**Amended AGENDA
CALIFORNIA TRAFFIC CONTROL DEVICES COMMITTEE (CTCDC)
May 14, 2009 Meeting
Los Angeles, Caltrans District 7 Office
Starting Time 9:00 A.M.**

**08-8 Bicycle and Motorcycle Detection at New or Upgraded Signalized Intersections
(Formerly known as “Traffic Actuated Signals for the Bicycles and Motorcyclists”)**

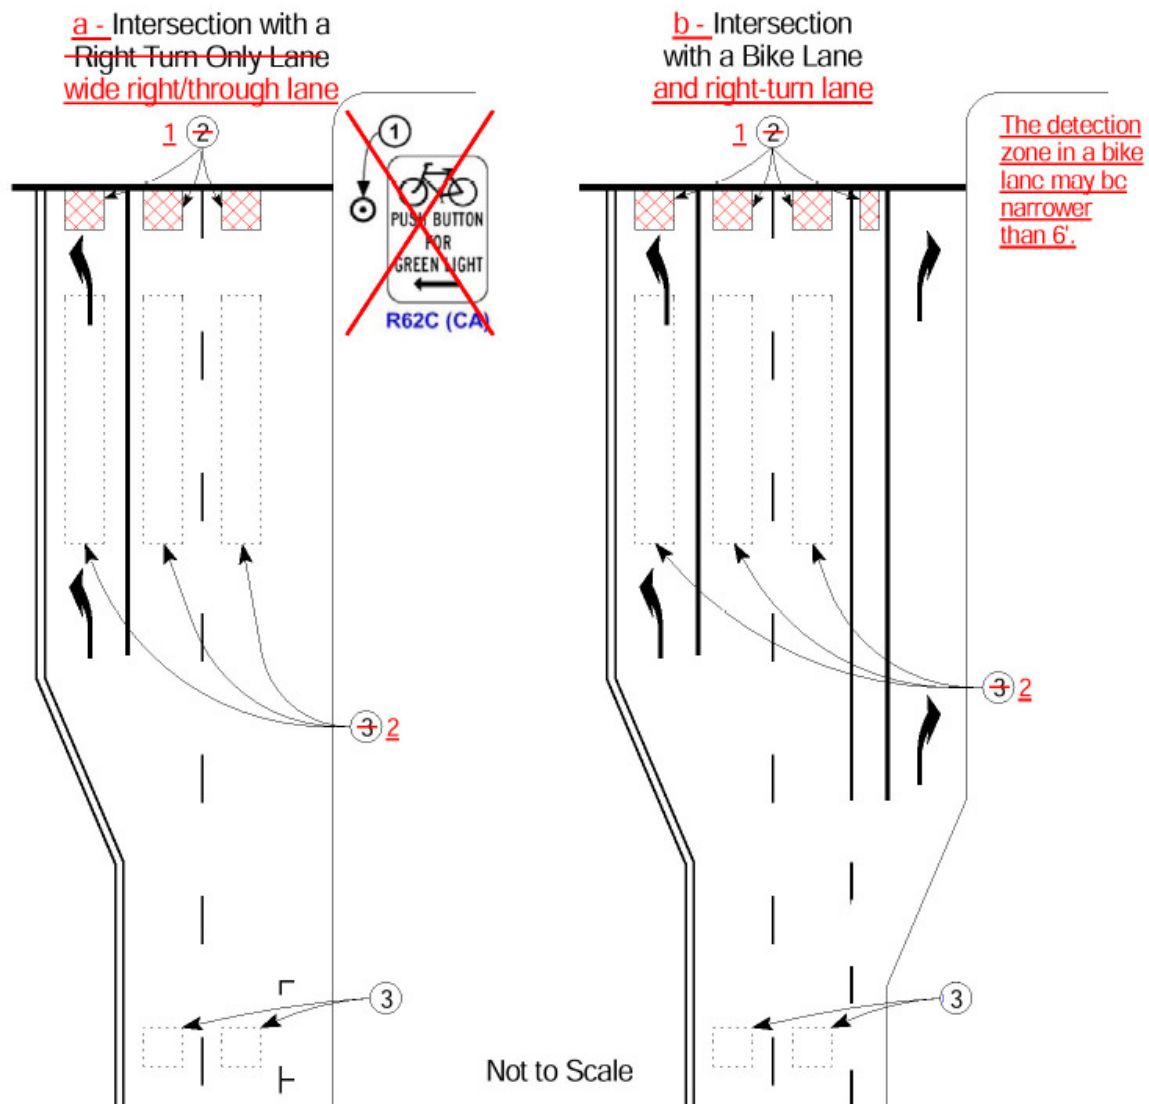
Signal timing: For all phases, the sum of the minimum green, plus the yellow change interval, plus any red clearance interval should be sufficient to allow a bicyclist riding a bicycle 6' long to clear the last conflicting lane at a speed of 14.7 ft/sec plus an additional effective start-up time of 6 seconds, according to the formula $G_{min} + Y + R_{clear} > 6 \text{ sec} + (w+6 \text{ ft})/14.7 \text{ ft/sec}$.

The speed of 14.7 ft/sec represents the final crossing speed and the effective start-up time of 6 seconds represents the time lost in reacting to the green light and then accelerating to full speed.

Examples of
Figure 4D-111(CA) Bicycle Detection Systems
(Sheet 1 of 3)

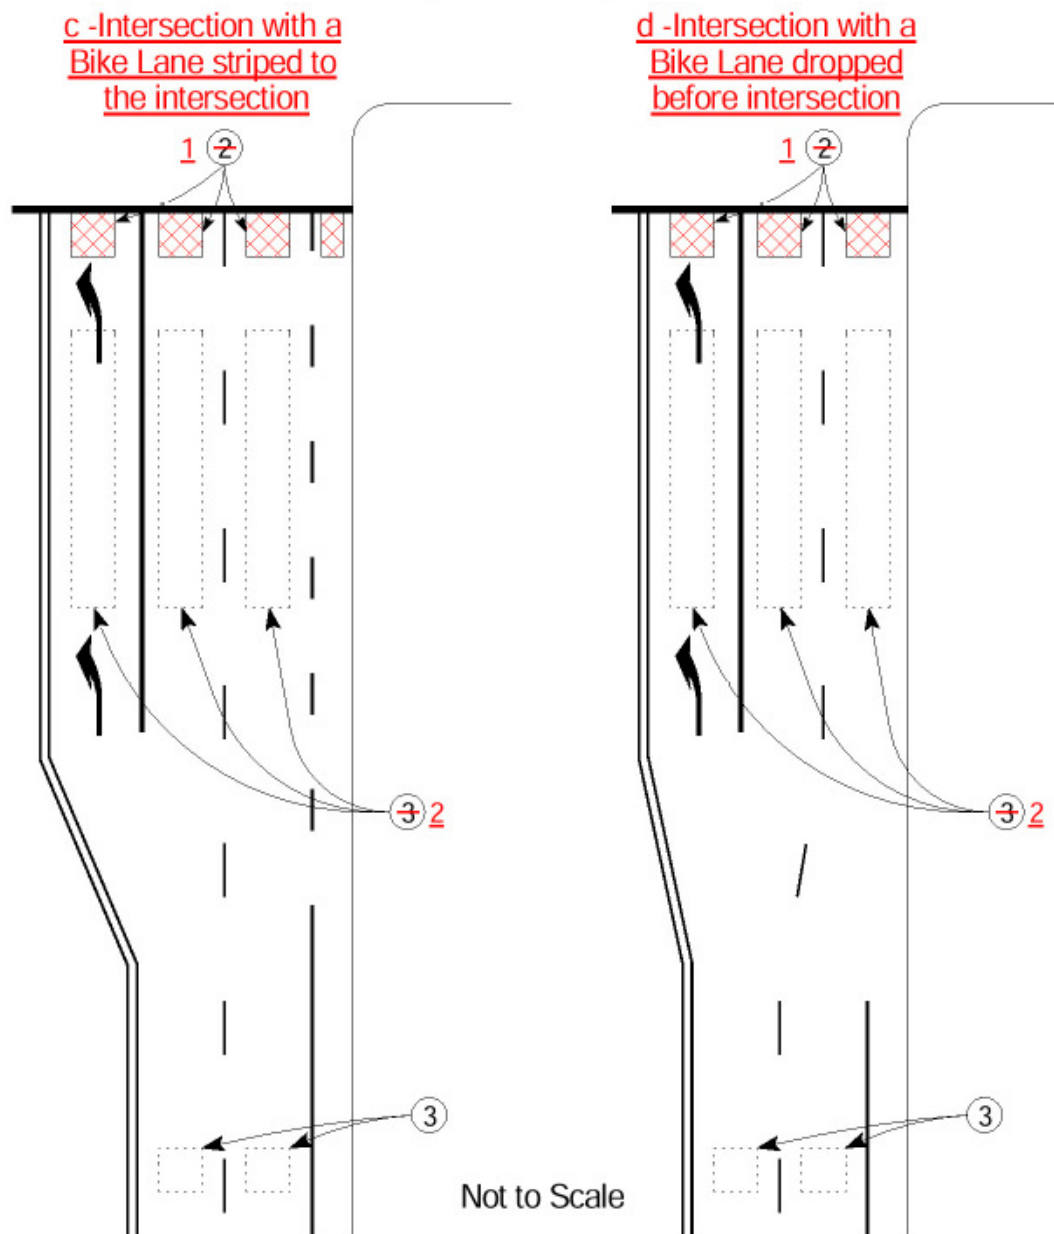
Revise Figure 4D-111(CA) as shown on the following pages.

- ~~1. Bike/Push Button for Green Light (R62C (CA)) Sign or a Type D Loop Detector may be used to activate a traffic signal. A push button should be located so it is convenient to use by bicyclists.~~
- ~~1-2. Typical Type D Loop Detector Locations. technology-neutral limit line detection locations. See Section 4D.105(CA).~~
- ~~2-3. Typical Loop Detector locations. See Section 4D.105 (CA). presence detection locations. See Section 4D.103(CA).~~
- ~~4. See Standard Plan A24C for Bicycle Loop Detector pavement marking details.~~
3. Typical advance detection locations.

Examples of
Figure 4D-111(CA) Bicycle Detection Systems
(Sheet 3 of 3)

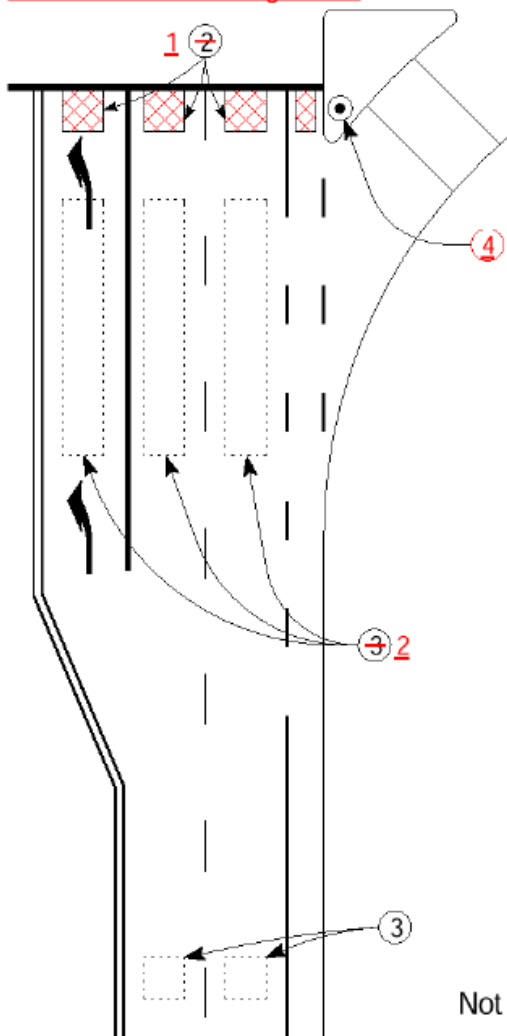
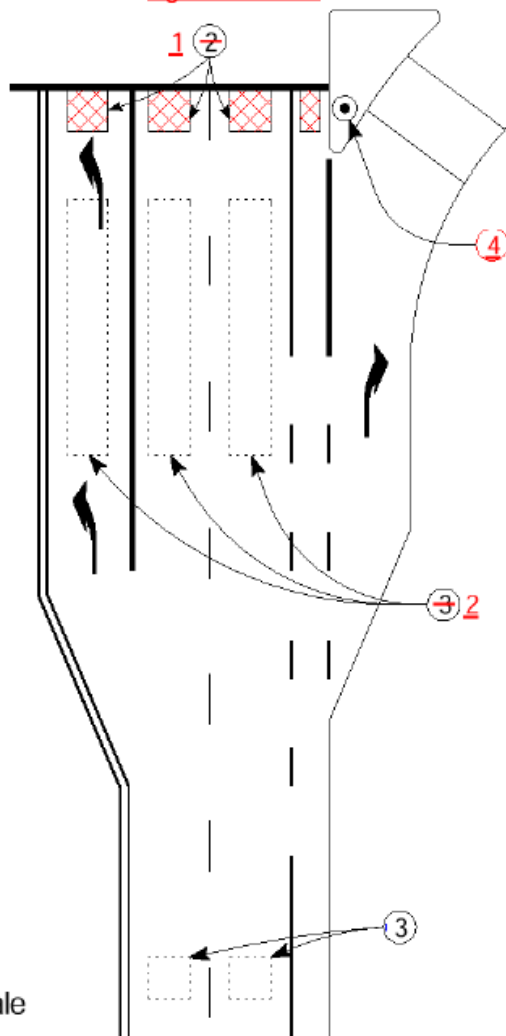
e - Intersection with a bike lane, a shared right/through lane and channelizing island

f - Intersection with a channelized right-turn lane

4. Typical bicyclist pushbutton locations. A bicyclist pushbutton may be used to supplement the required limit line detection where (1) some bicyclists might stop next to the curb or edge of pavement, (2) the lane is wide enough for a bicycle and a vehicle to travel safely side by side within the lane, and (3) vehicular right turns are either prohibited or not authorized. See Section 9B.10 for bicycle regulatory signs.

Figure 404.5C
STAA – Long Tractor

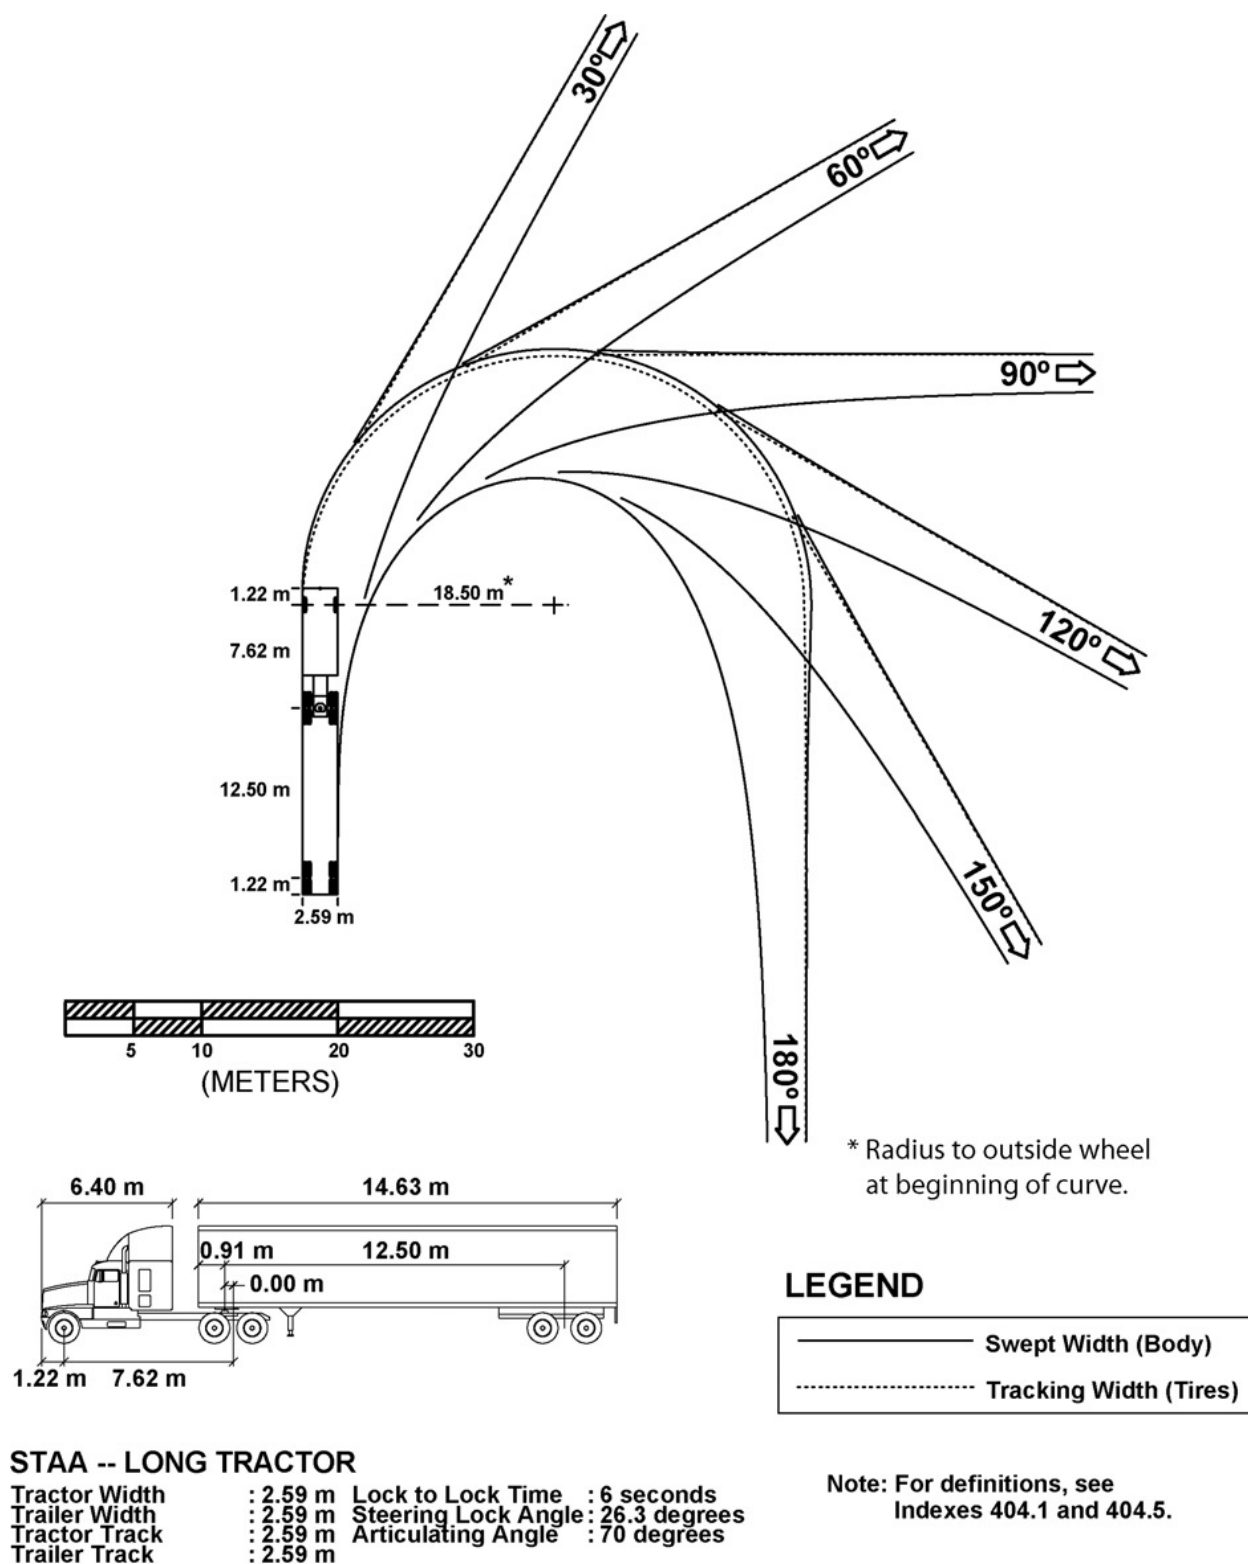
(c) STAA Vehicle – Long Tractor. Since the 1980’s, many truck tractors have longer wheelbases, a few reaching 7.62 m and even up to 9.14 m. The STAA Vehicle – Long Tractor in Figure 404.5C illustrates a truck tractor with a wheelbase of 7.62 m. In recent years, the highway system has experienced an increase

Attachment 2 – Proposed Replacement Signage showing usage of “EXPRESS LANE” instead of “CARPOOL”

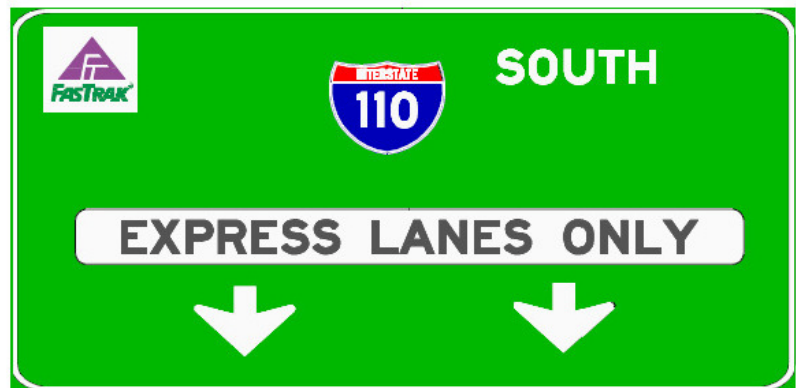
Caltrans is proposing the usage of “EXPRESS LANES” and “HOV” in lieu of “CARPOOL” on all signage related to the Los Angeles Express Lanes. Appendix A illustrates the proposed access signing plan, which includes the typical usage of “HOV” within the project area. “HOV” would also be used on the roadside signs that provide occupancy requirements.

EXISTING SIGN PANEL

REPLACEMENT SIGN PANEL

Fig. 1, Aerial view, southbound Atlantic Blvd. at Telegraph Rd., City of Commerce (arrow points to the limit line for southbound traffic)

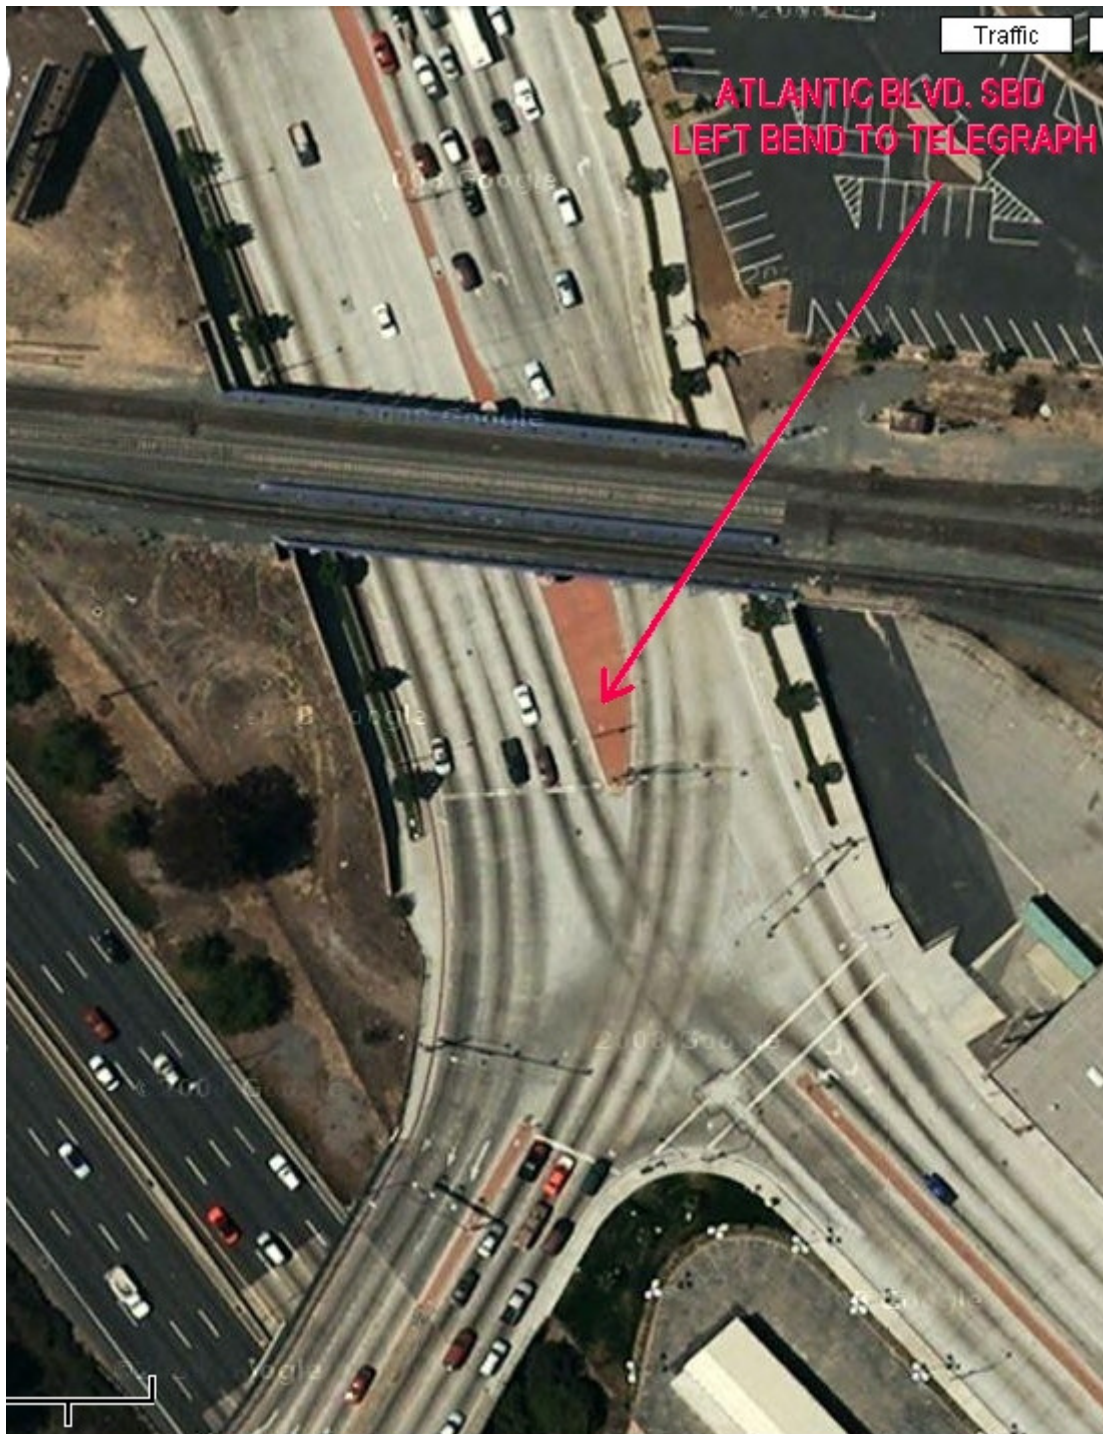
In the twelve months of 2008 the City of Commerce issued 3630 tickets to motorists making the partial left turn from southbound Atlantic Boulevard to Telegraph Road. The arrow in Figure 1, below, points towards the limit line for that movement.

As can be seen from the aerial view (Figure 1), the Atlantic/Telegraph movement is an approx. 20 degree, large-radius bend to the left involving two un-pocketed lanes. The City of Commerce evidently has treated this movement as a protected left turn and has set the length of the yellow at 3.0 seconds, in apparent reliance on the Traffic Manual, which says:

This intersection design is commonly used at onramps - but rarely enforced with a camera. I recommend that where these intersections are enforced via a red light camera, the agency doing the enforcement or operating the intersection be required to make an engineering study before the camera is installed and, once the camera is in operation, to make improvements to the intersection to ensure that the number of violations decreases over time. For left turns, I propose the following language for the California MUTCD, Section 4D.10 (Yellow Change and Red Clearance Intervals):
